Access Compliance Report

Public Rights-of-Way

Intersection ID: 17902	Main Street: MONROE_RD	Cross Street: CONFERENCE_DR	Location: SE
ADA ID: B18AB5EA0911	Ramp Type: Perp	Initial Pass/Fail: Fail	Overall Compliance: No
Severity Score: 13.75			
Codes/Mitigation Info/Possible Solution		Field Measurements/Component Compliance

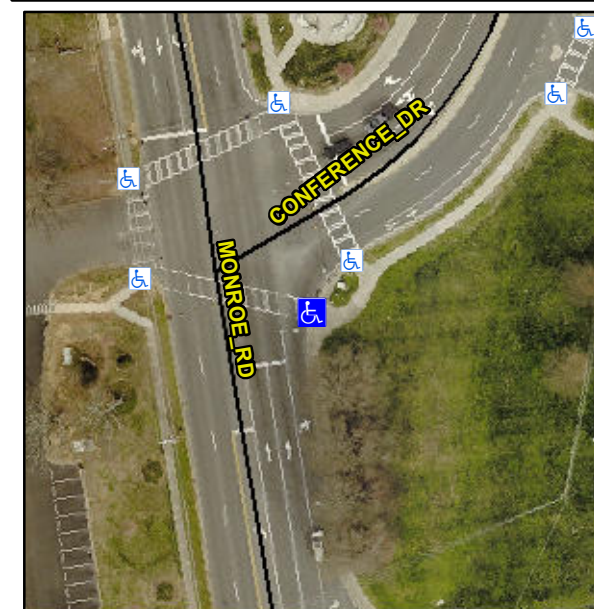
Not Found, R304.2.2, R304.5.3

Compliance	Description	Data	Compliance	Description	Data
N/A	Ramp Length (in)	72.0	No	Ramp Slope (%)	8.8
Yes	Ramp Width (in)	48.0	No	Ramp XSlope (%)	2.8
N/A	Flare Type LT	N/A	N/A	Flare Type RT	N/A
N/A	Flare Slope LT (%)	N/A	N/A	Flare Slope RT (%)	N/A
N/A	Flare Traversable LT?	N/A	N/A	Flare Traversable RT?	N/A
N/A	Landing Length (in)	N/A	N/A	DWS Provided?	N/A
N/A	Landing Width (in)	N/A	N/A	DWS Contrast?	N/A
N/A	Landing Slope (%)	N/A	N/A	DWS Length (in)	N/A
N/A	Landing X Slope (%)	N/A	N/A	DWS Full Width?	N/A
N/A	Landing Curb? (Y/N)	N/A	N/A	DWS Offset (in)	N/A
N/A	Shared Landing?	N/A			
N/A	Gutter Ponding?	N/A	N/A	Gutter Slope (%)	N/A
N/A	Gutter Lip Ht (in)	N/A	N/A	Gutter X Slope (%)	N/A
N/A	Painted X Walk1?	Yes	N/A	Painted X Walk2?	N/A
	X Walk 1 Direction	To NW		X Walk 2 Direction	N/A
N/A	X Walk 1 Width (in)	110.0	N/A	X Walk 2 Width (in)	N/A
	X Walk 1 Slope (%)	6.7		X Walk 2 Slope (%)	N/A
	X Walk 1 X Slope (%)	0.9		X Walk 2 X Slope (%)	N/A

Remove & Replace Entire Ramp.
